Environmental Impact Assessment
for the
Proposed Mining of Bauxite
in the
Special Mining Lease 173 (SML 173) Area
in the parishes of
St. Ann and Trelawny

**Responses to Additional Comments Received from the
Public by the National Environment & Planning
Agency**

March 10, 2021

Figure 3: From right to left - Watt Town Greenhouse cluster on rehabilitated lands | Cabbage Growing on rehabilitated lands at Higgins Land Greenhouses | Pond established on Rehabilitated land | Aerial showing rows of corn thriving on

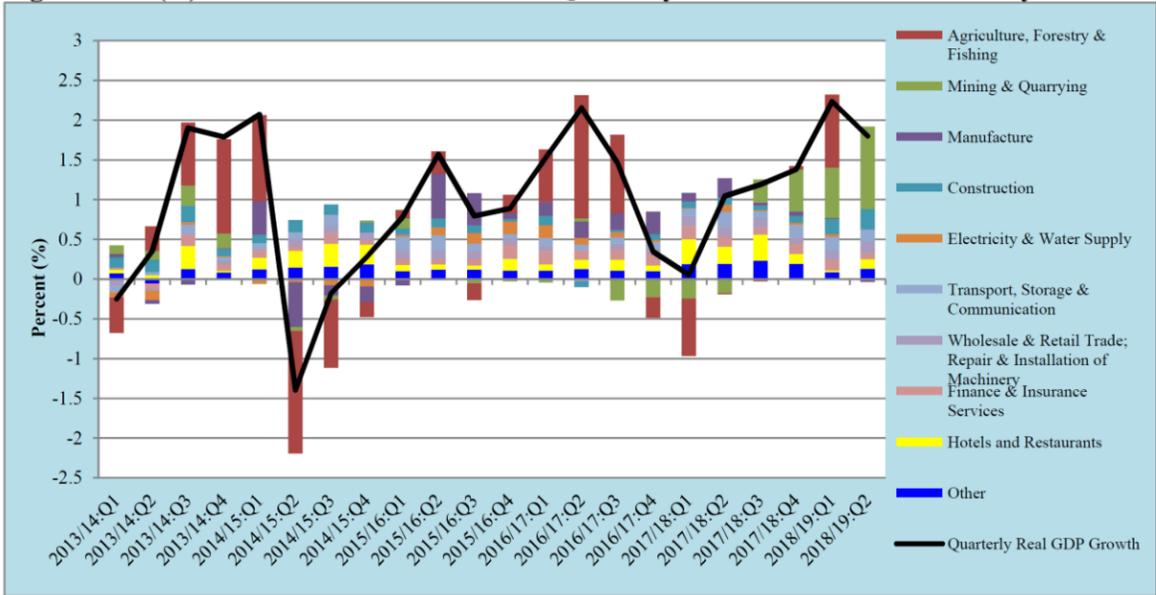
No	Comment	Section of ToR within which this topic would be discussed	CD&A/NJBP II Response
1.	<p>No assessment was included in the EIA of the negative short-term/immediate impact on the farming communities.</p> <p>There is no evidence of what livelihood activities will occur over the intervening period between mining and rehabilitation to substitute or compensate for livelihood losses.</p> <p><u>Response to this issue in correspondence dated 20 January 2021 is noted however it does not adequately address the issue as further highlighted.</u></p>	<p>8.5. Human/Social/Cultural</p> <p><i>Effects of mining on the socio-economic status such as changes to public access and recreational use; impacts of the proposed mining activities on existing and potential economic activities; contribution of the development to the national economy and development of surrounding communities should be examined. Socio-economic and cultural impacts to include land use/resource effects, health and safety of the potential workers as well as the residents of the surrounding environs should be described. Public perception as it relates to loss of property value, loss of aesthetic enjoyment, loss of livelihoods among other things should be explored.</i></p>	<p>CD&A again reiterates that this statement is incorrect.</p> <p>The data required for the socio-cultural and economic survey was captured by a survey instrument (questionnaire), which was administered to an appropriate sample size (See Section 5.5.1. Introduction, page 5-275 of the EIA Report). The socio-cultural and economic survey instrument (See Appendix III of the EIA Report) was approved by NEPA (See Appendix II below). The study complies with the agreed ToR (See Appendix I of the EIA Report). CD&A also consulted relevant literature including data from the Social Development Commission (SDC) and the Statistical Institute of Jamaica (STATIN), among others.</p> <p>Further, the EIA Report addresses the following:</p> <ol style="list-style-type: none"> <u>The offer of compensation</u>, in certain circumstances, to farmers and land owners whose activities may be temporarily dislocated due to the mining process. <u>This compensation occurs over the intervening period between mining and rehabilitation.</u> After mining, the rehabilitated lands are returned to the land owners or previous occupiers. Slide 6 of the Mandatory Public Meeting presentation made on December 8, 2020 stated that: “<i>The SML 173 area comprises private and government holdings of which, approximately, 70% is titled. Untitled lands are privately owned. Noranda holds 55% of the total land areas (for and behalf of the Commissioner of Lands) and the remainder is privately held (See EIA Report Volume 1: Appendix V). If mining rights is required for any privately owned land, Noranda is obliged to pay fair and reasonable compensation to the owner or occupier for disturbance of surface rights, any damage to the land, affected crops and buildings. Upon completion of mining, the land will be rehabilitated in accordance with applicable laws and returned to the landowner or occupier.</i>” In the case of private lands, the rehabilitated lands are returned to the farmer (as one option) for their continued use. The recommendation that, where practicable, displaced farmers should be accommodated for continuation of farming in the ‘clawed back area’. <u>This again stresses the proposed mitigation to the disruption during the intervening period between the mining and rehabilitation period.</u> <p>In “Section 10: Alternative Analysis” (pages 10-6 to 10-7 of the EIA Report), the third (3rd) alternative referred to the ‘clawed back area’, within which there is intensive agricultural production. This alternative proposes that there will</p>

No	Comment	Section of ToR within which this topic would be discussed	CD&A/NJBP II Response
			<p>rehabilitated land Land being prepared for planting on rehabilitated lands Sweet Potato being planted on rehabilitated lands</p> <p>In addition, it must be highlighted that:</p> <ol style="list-style-type: none"> 1. NJBP II owns 55% of the mining rights in SML 173. 2. The basis of capturing data is the survey instrument and this was reviewed and approved by NEPA (See Appendix I of the EIA Report and Appendix II below). 3. The AIA (See Volume III of the EIA Report) addresses the cultural and historical heritage resources in SML 173. 4. The inclusion of the '<i>clawed back area</i>' option in the Alternative Analysis section (See Section 10.4 of the EIA Report) also takes into consideration the short term impact of the mining activities on the livelihoods of the farmers.

Figure 12: Terrestrial Ecology Study Area Blocks within SML 173 (numbered 1-9) (Source: EIA Report)

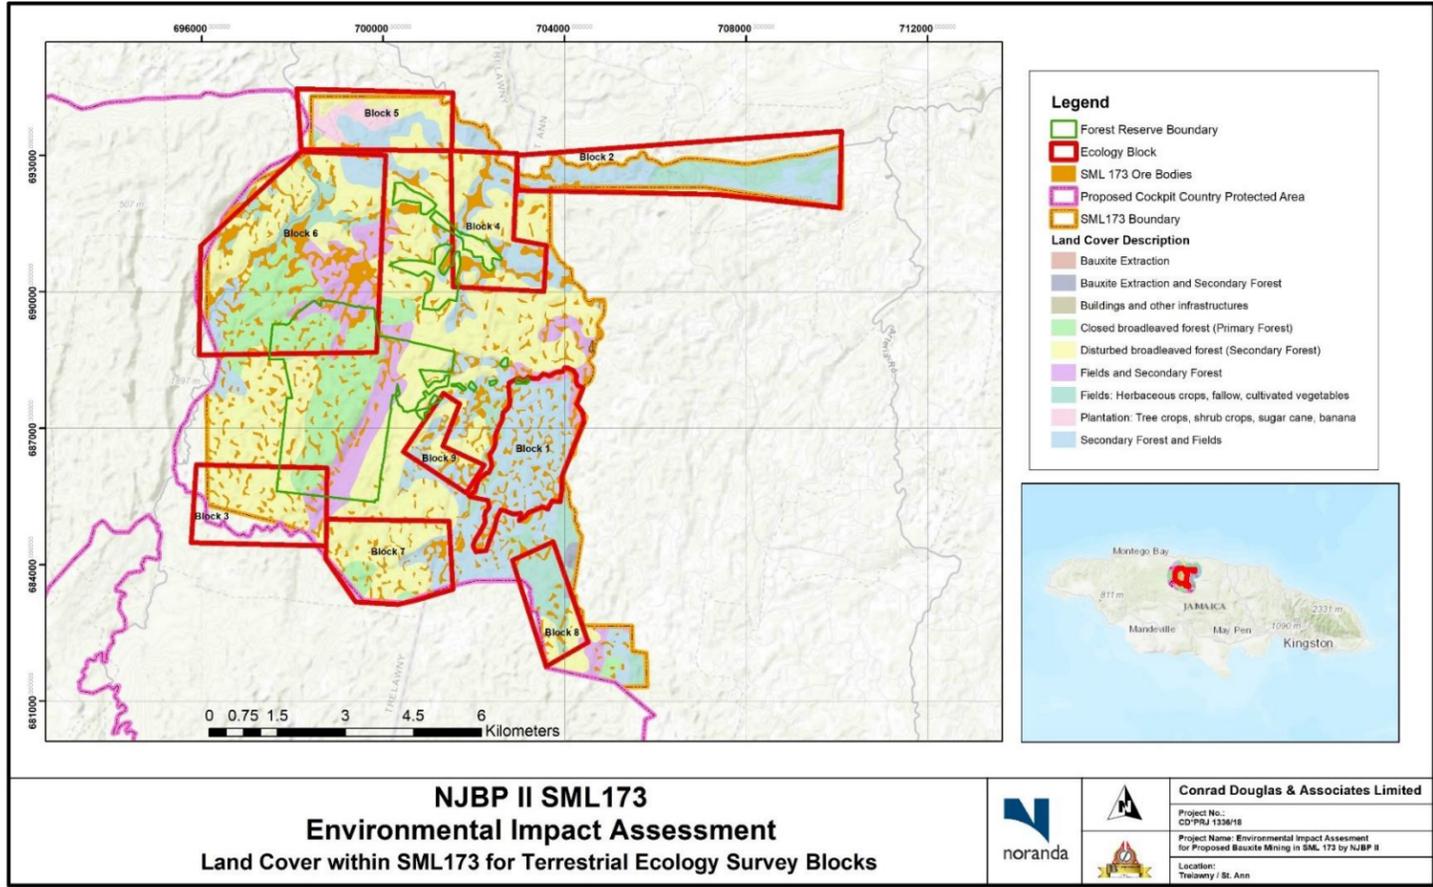
16.	<p>Methodology</p> <p>It is well established that seasons play a significant role in the ecology of animals. Consequently the fauna of any area is likely to change with the seasons. This study was conducted in August 2019 only and is thus not likely to provide a true picture of the biodiversity of the area.</p>	<p>6.4. Biological Environment</p> <p><i>CD&A will present a detailed description of the flora and fauna (terrestrial) of the area, with special emphasis on rare, endemic, protected or endangered species. In this section the emphasis is on a description of habitats, flora and</i></p>	<p>It is incorrect to state that the study was undertaken only in August 2019. The field investigations covered both the wet and dry seasons and nocturnal studies. Field visits were conducted within SML 173 and its environs covering a period of 20 months over the period February 2018 to December 2019:</p> <ul style="list-style-type: none"> i. February 2018, ii. August 2018, iii. August to September 2019, and

No	Comment	Section of ToR within which this topic would be discussed	CD&A/NJBP II Response
	<p>On page 5-82, the EIA states that faunal assessments were undertaken during Phase 2 of field surveys, during the period of August 17-19, August 24-26, 2019 and September 14-16, 2019. “December 2019” also was included on pg 5-66, but it remains unnoted what was surveyed during that period. What ecologically-relevant criteria were used to determine the timing of faunal surveys so as to ensure that all fauna present in the area were detectable, especially in relation to the survey methods utilized? The timing of mid-to-late August and mid-September suggests that the consultants are not aware of the abiotic factors to which breeding seasons, insect emergence patterns, and seasonal intra-island and international migration patterns are linked i.e., those conditions which influence species’ presence and detectability. Why were surveys not conducted in association with the cyclic bimodal rainfall pattern (e.g. pg 5-34), which drives faunal ecologies and detectability?</p> <p>Overall the consultant needed a longer timeline to carry out the fauna and flora study in such a sensitive area. It would have accounted for seasonal variation in the species encountered such as dry vs wet season.</p> <p>There should be more sample points over the study site to account for the variation in the habitat.</p> <p>The extent of sampling of the forest ecosystems is inadequate and the number of plant and animal species, especially of the number of endemic species, appears low. Apart from</p>	<p><i>fauna surveys inclusive of a species list; commentary on the ecological health, function and value in the project area, threats and conservation significance.</i></p> <p><i>This will include:</i></p> <ul style="list-style-type: none"> ☐ <i>A detailed qualitative and quantitative assessment of terrestrial habitats in and around the proposed project sites and the areas of impact. This will also include flora and fauna surveys and will include species lists.</i> ☐ <i>Special emphasis will be placed on rare, endemic, protected or endangered species. Migratory species will also be considered. As well as economically important species and nocturnal species.</i> ☐ <i>Species dependence, niche specificity, community structure, population dynamics, species richness and evenness (a measure of diversity) ought to be evaluated.</i> <p><i>The field data collected will include, but not be limited to:</i></p> <ul style="list-style-type: none"> ☐ <i>Vegetation profile</i> ☐ <i>Species lists will be provided for each community</i> ☐ <i>A habitat map of the area</i> 	<p>iv. December 2019.</p> <p>Further, the nine blocks covered more than 50% of the 8,335 hectares SML 173 area, or 2.5 times of what best practice requires. It included all land uses within the area. Nine sampling blocks were used (Please see Figure 12 below and pages 5-71 to 5-84 of the EIA Report). The study was carried out comprehensively using universally acceptable scientific methods. The sampling methods used are described in “Section 5.3.2. Approach & Methodology” on pages 5-70 to 5-127 of the EIA Report.</p> <div data-bbox="1339 600 2772 1487" style="text-align: center;">  <p>NJBP II SML173 Environmental Impact Assessment Land Cover within SML173 for Terrestrial Ecology Survey Blocks</p> <p>Conrad Douglas & Associates Limited Project No: CD*PRJ 1336/18 Project Name: Environmental Impact Assessment for Proposed Bauxite Mining in SML 173 by NJBP II Location: Trawney / St. Ann</p> </div>

Figure 17: Location of Mollusks (Source: iDigBio.org)

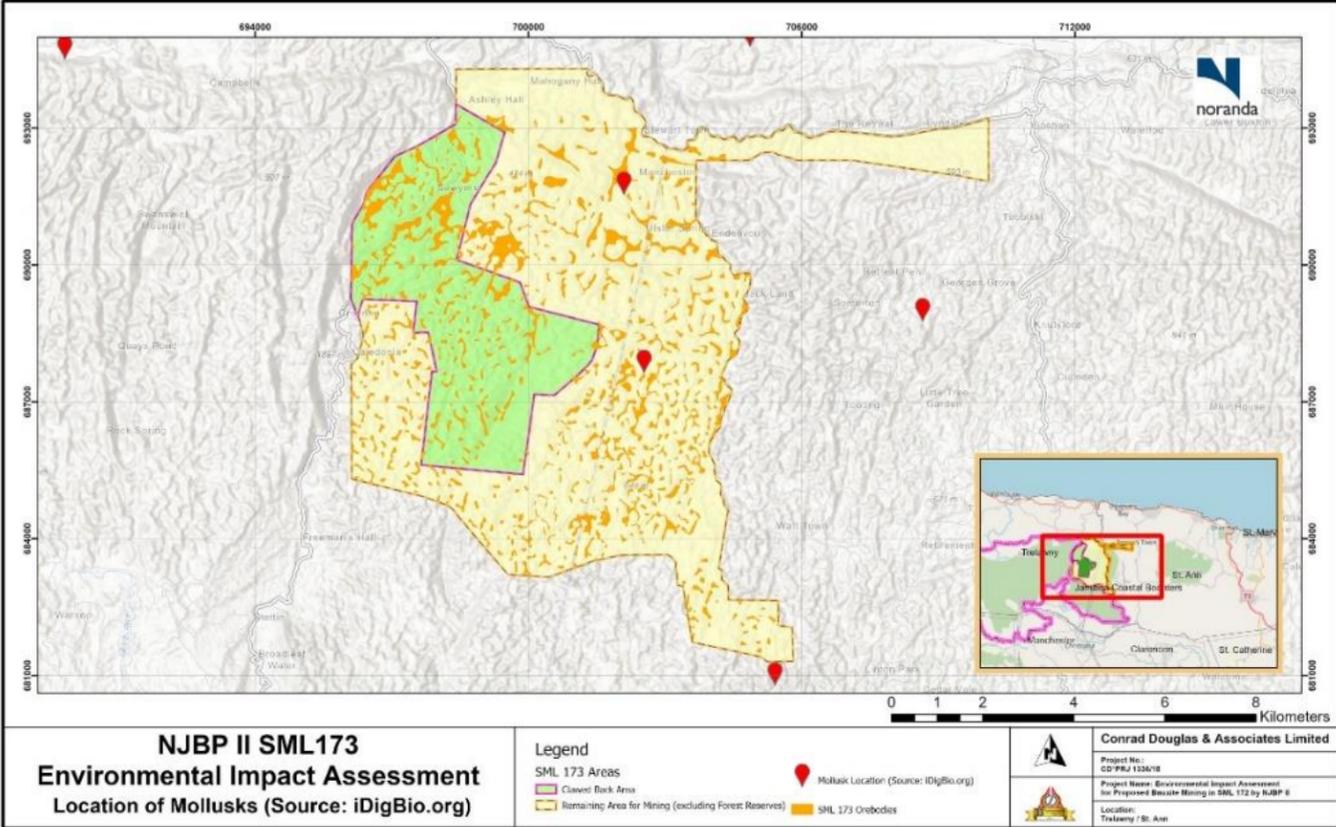
No	Comment	Section of ToR within which this topic would be discussed	CD&A/NJBP II Response
	<p>☐ Jamaica’s molluscan diversity is highly localized and when one area is disrupted for mining, quarrying, or damming, it can have a devastating effect on the local endemic species and contribute to their extinction.</p>		 <p>NJBP II SML173 Environmental Impact Assessment Location of Mollusks (Source: iDigBio.org)</p> <p>Legend SML 173 Areas Cloned Back Areas Remaining Area for Mining (excluding Forest Reserves) SML 173 Orebodies</p> <p>Mollusk Location (Source: iDigBio.org)</p> <p>Conrad Douglas & Associates Limited Project No.: CD*PRJ 1336/18 Project Name: Environmental Impact Assessment for Proposed Bauxite Mining in SML 173 by NJBP II Location: Trelawny / St. Ann</p>

After review of the information and data referenced in this section we are unable to verify the claim of 103 species and any work being done specific to SML 173. Neither the Jamaican Biotic Survey Dataset 2019; Google LLC 2020 nor the iDigBio (2020) support the abundance that is being suggested by the review.
